From: Richard Temple
Sent: 12 February 2018 08:40
To: Nicola Spencer
Cc: Charlotte Burrows
Subject: FW: AL/115/17/OUT - Arboriculture - Wings Nursery

From: Gareth Giles | Whaleback [REDACTED]
Sent: 10 February 2018 15:46
To: Richard Temple
Cc: Richard Dollamore; [REDACTED] Michael
Subject: AL/115/17/OUT - Arboriculture - Wings Nursery

Further to the Consultant Arboriculturist consultation response - dated 5th December 2017 and uploaded to the Register on 11th January 2018 - our Arboriculture Consultant has provided the response below to address the issues raised.

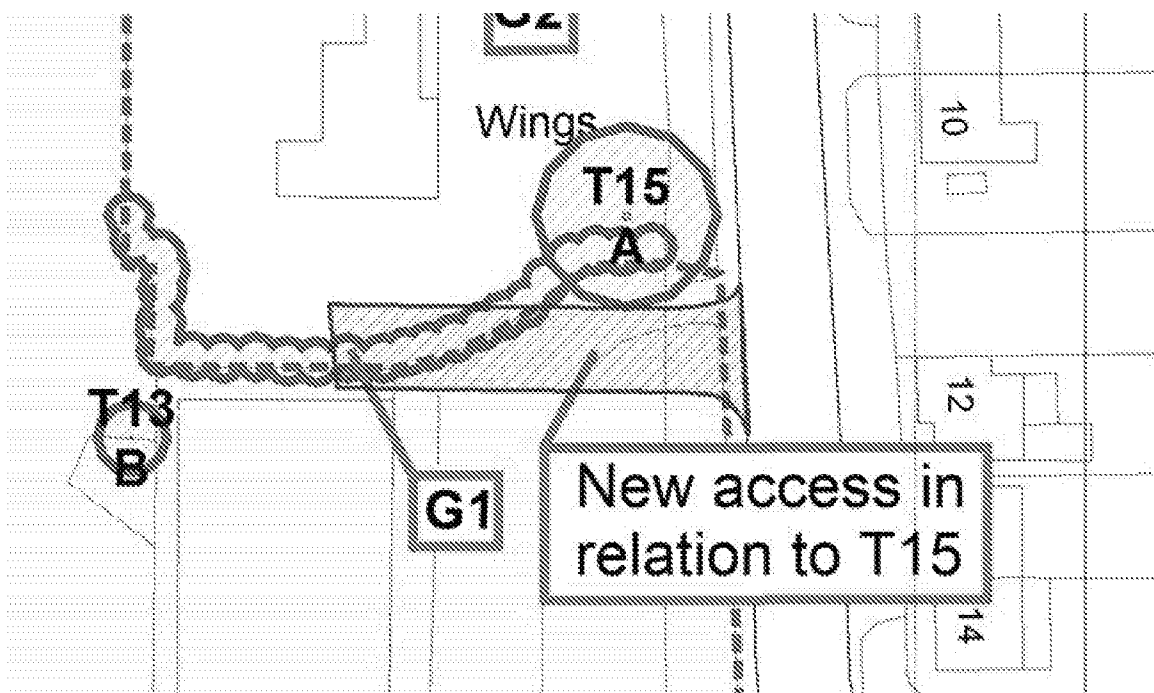
[...] Although the proposed site layout plan doesn't show the root protection areas of existing trees it does appear that, with the exception of the category B English oak (T13), the siting of buildings and roads are within the developable area identified in our report (**Beechdown ref: B/0173/17**).

With regard to the prominent category A English oak (T15) in the grounds of Wings, there is an existing access from Lidsey Road where the main drive is indicated on your plan and as far as I can tell, although construction of the driveway will require the removal of part or all of the category C Leyland cypress hedge (G1), the northern edge of the proposed access drive barely reaches the southern extent of T15's RPA (see below) so it needn't be removed; however, tree protection, supervision and monitoring, as detailed in a conditioned method statement will have to be adopted to ensure that no damage to the roots or rooting environment occurs.

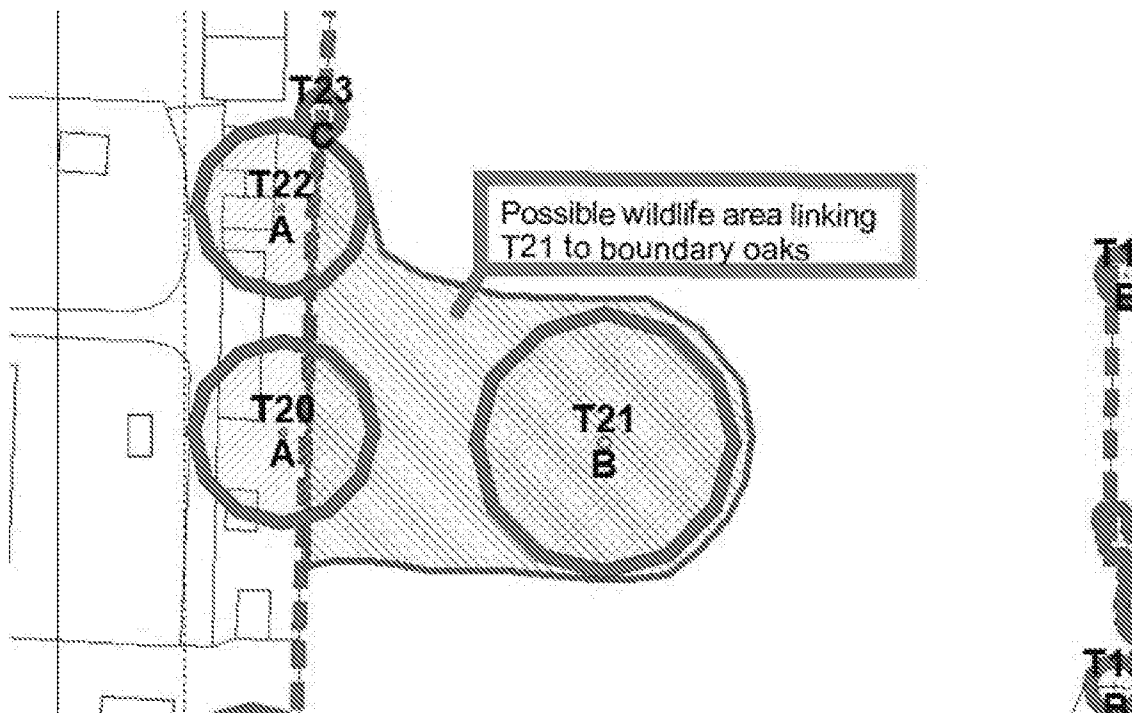
Construction of dwelling 55, although close to the category B English oak (T12), takes place beyond its RPA so it could be retained in the short –term; however, as the tree increases in size there may be pressure for future removal or excessive pruning. The proposed site layout plan indicates there will be extensive tree planting. Where space allows this planting should include specimens of English oak, sweet chestnut and perhaps field maples – native species that can attain large proportions and add maturity to the development proposal.

The veteran oak (T21) is identified as a tree with valuable habitat potential that should be retained and managed for both habitat and risk. The site layout plan shows a relatively large area around it and to the south-east that is undeveloped but a car-park between it and the western boundary. Although, with suitable working practices, construction of the car-park need not impact upon the RPA of the tree I am concerned that it may become a little isolated towards the middle of the site. If the parking spaces could be repositioned somewhere to the south-east of the tree and dwellings 16, 17, 18, 19, 20 and the flats moved marginally to the south then it may be possible to keep a wild area linking T21 (see below) to the mature oaks beyond the western boundary. The existing coppiced field maple, elder and grey willow could be retained along with additional planting of low level, scrubby native species i.e. hawthorn, blackthorn, hazel, spindle, guelder rose etc. As well as the potential wildlife benefits this planting would limit pedestrian access to base of the tree and reduce the potential for soil compaction within the RPA. Restricted access to the tree would also reduce the risk of injury in the event of stem or branch failure and may allow habitat features – branch fractures, major deadwood etc. – to be retained that may otherwise have to be removed if the tree is in an area of easy open access.
